From: Jonathan Merheb, P.E.

Re: Revision 4 Narrative
Proposed Single Family Home
Site Plan & Architectural Review Approval
467 ½ Munroe Ave
Sleepy Hollow, NY 10591
Tax ID: 115.7-4-10

Revision 3 Summary

1 GRADING & DRAINAGE PLAN
C-2 SCALE: 1" = 10'-0"

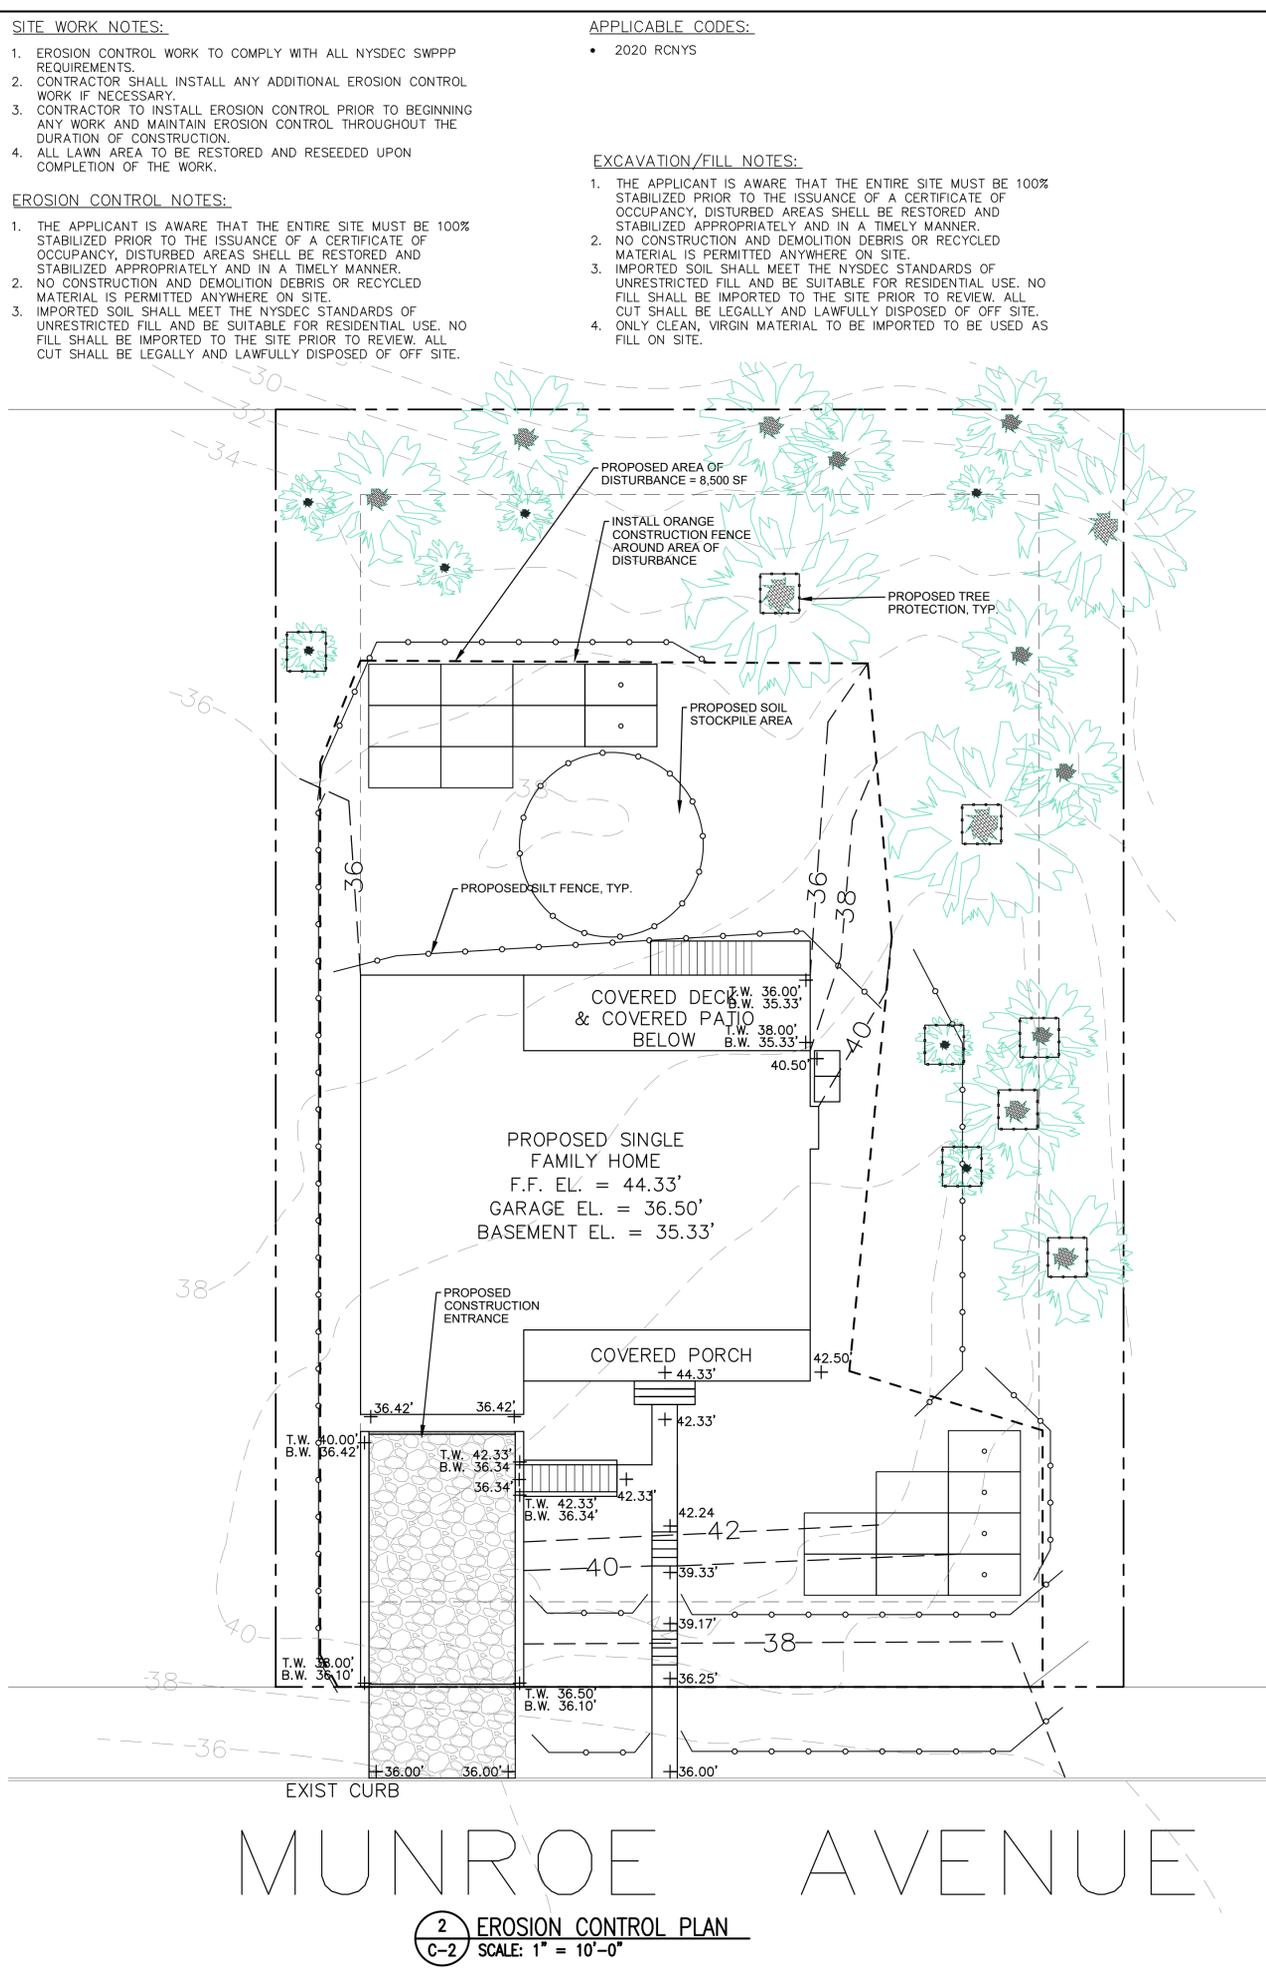
1. Site Plan C-2 has been revised (revision date 2/2/26) with following changes:
 - a. 1/C-2 Proposed Grading & Drainage Plan has been revised to add 3 additional Cultec 330XL HD infiltrator units (making 22 total units).

1 PROPOSED LANDSCAPE PLAN
SCALE: 1" = 10'-0"

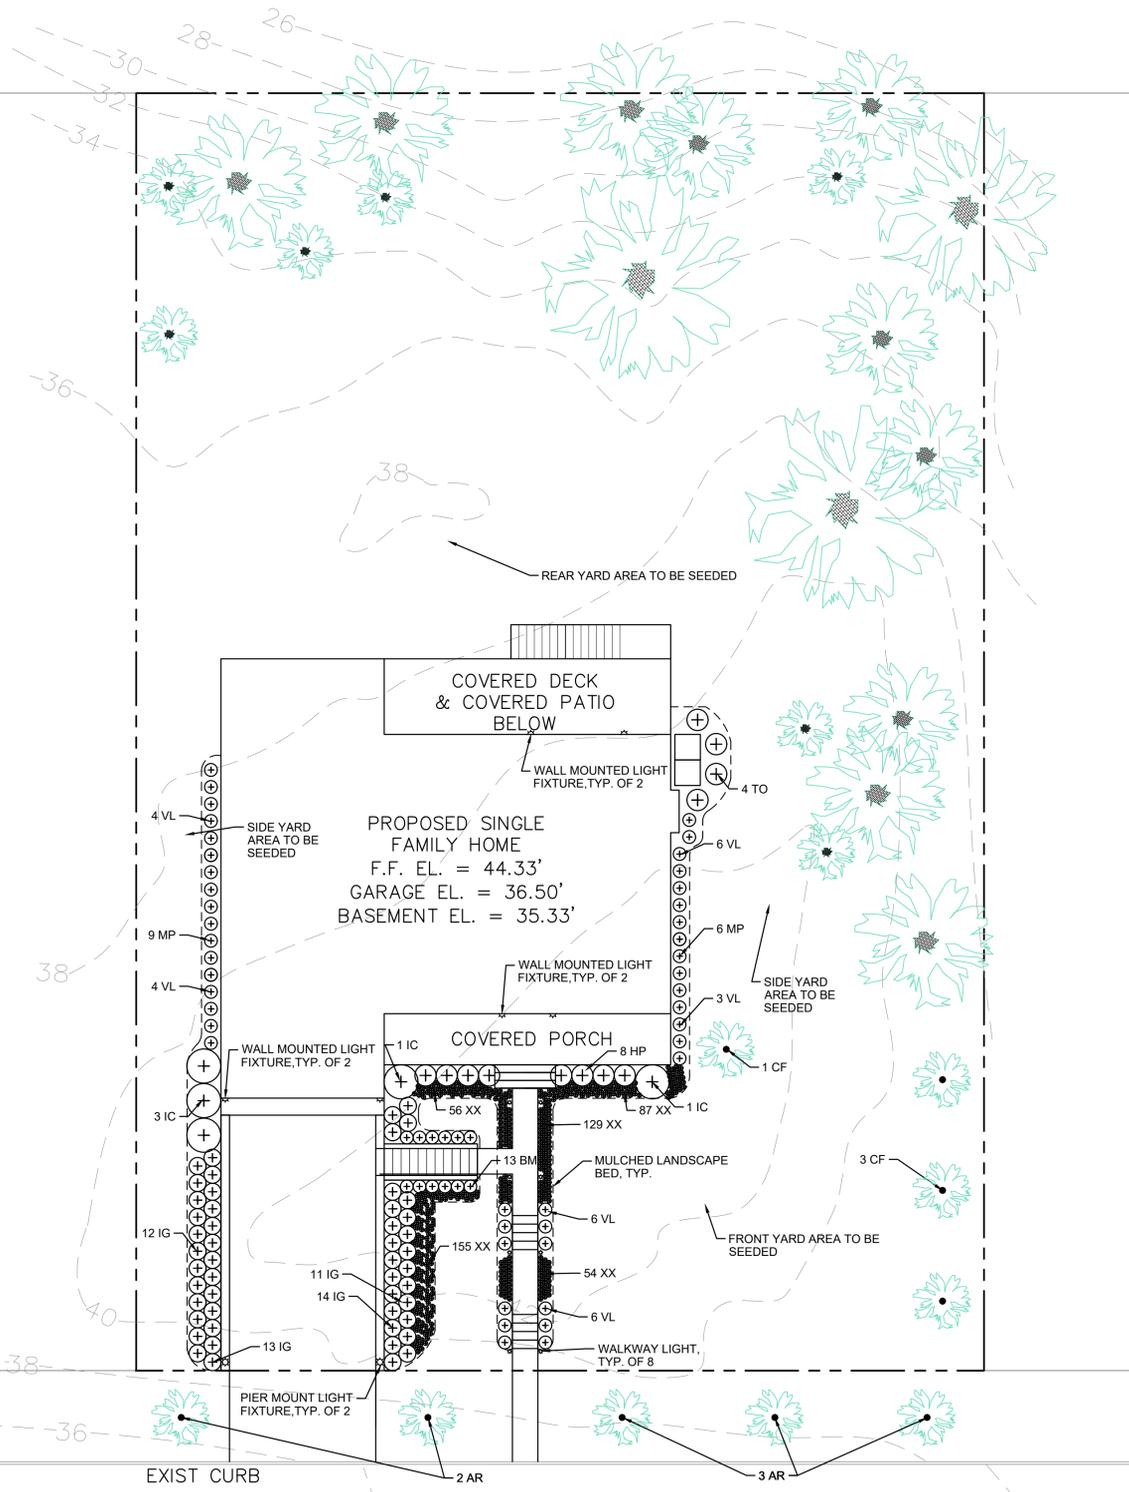
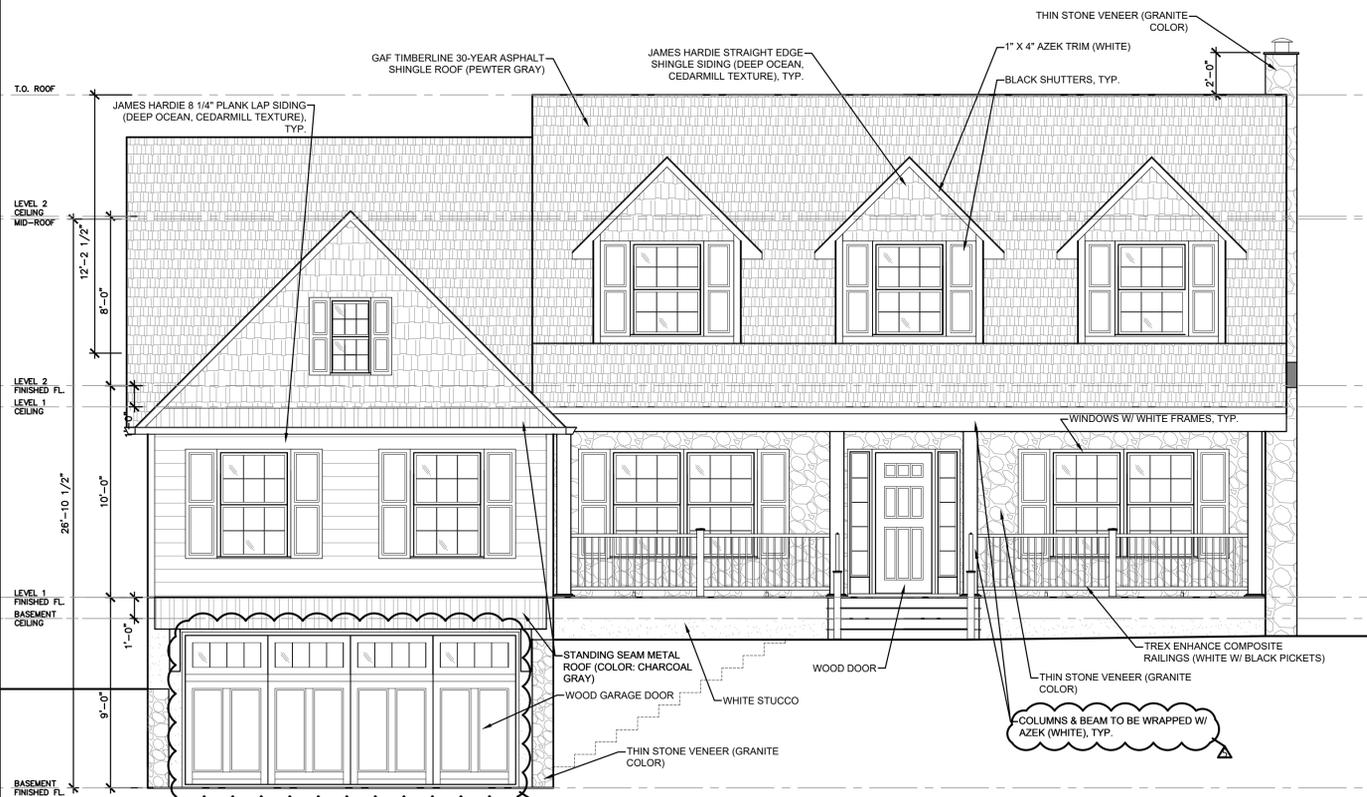
2. Site Plan C-3 has been revised (revision date 2/2/26) with the following changes:
 - a. 1/C-3 Proposed Landscape Plan has been revised to change tree species and quantity of trees in the town right of way at the front of the home.

- b. 1/C-3 Proposed Landscape Plan has been revised to add additional trees around the home & at the Northern property line.
 - c. 1/C-3 Proposed Landscape Plan has been revised to add more dense shrubbery along the driveway retaining walls to serve as a buffer in order to eliminate railings.

- d. 1/C-3 Proposed Landscape Plan has been revised to add differing species of shrubbery around the perimeter of the home.
 - e. 1/C-3 Proposed Landscape Plan has been revised to delineate mulched landscape beds.

1 FRONT ELEVATION (EAST)
A-3 SCALE: 1/4" = 1'-0"

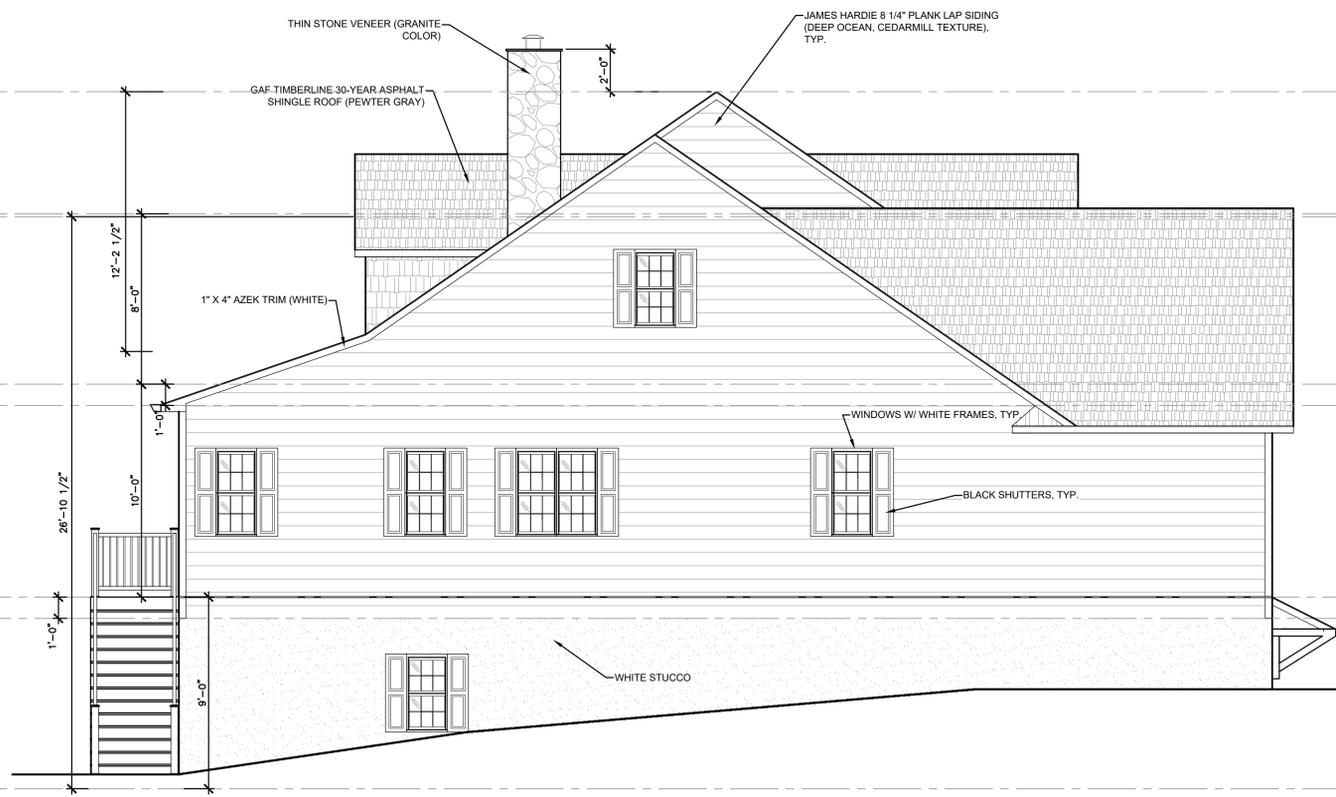
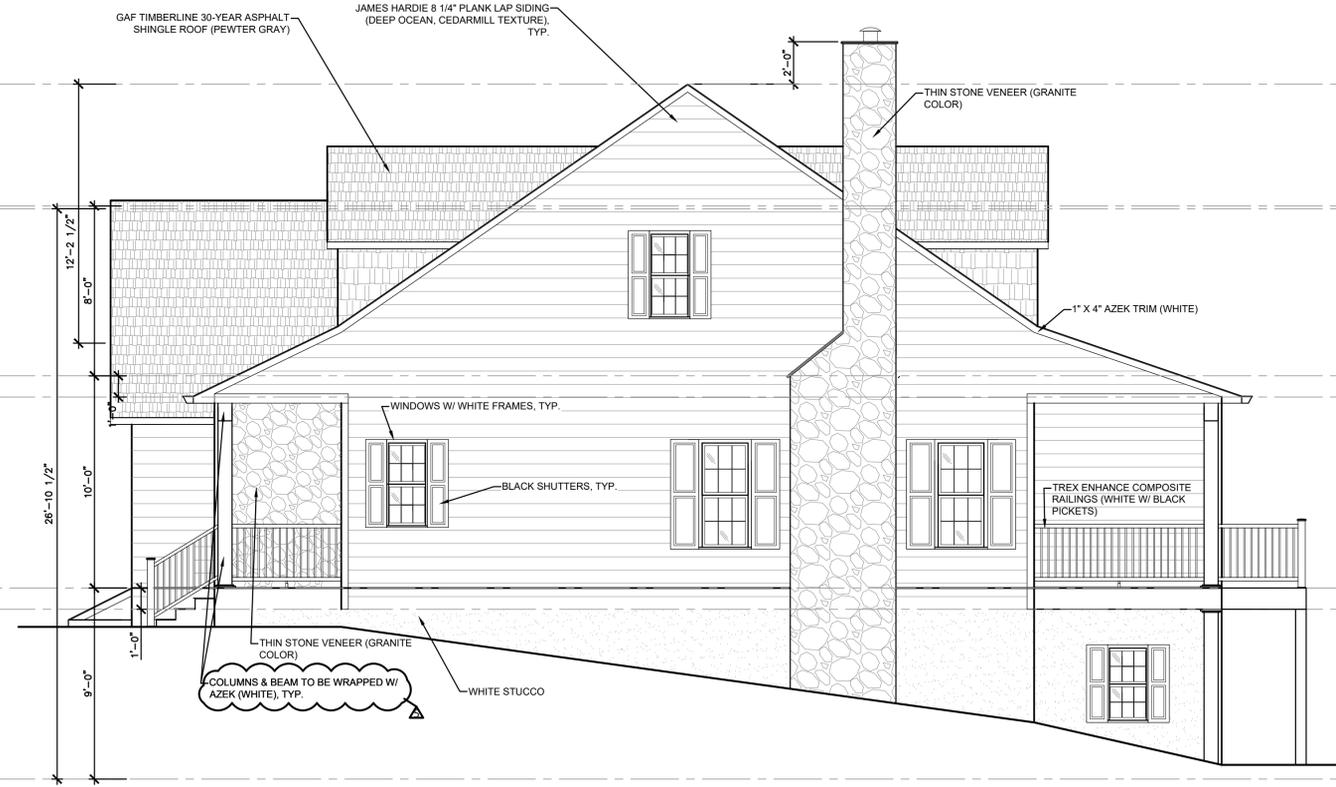
3. House Plan A-3 has been revised (revision date 2/2/26) with the following changes:
 - a. 1/A-3 Proposed Front Elevation has been revised to change the style of the garage door.

- b. 1,3&4/A-3 Proposed Elevations have been revised to show a beam at the front and rear porches.
4. Drainage calculations have been revised.
5. Renderings have been updated to reflect changes to the home.
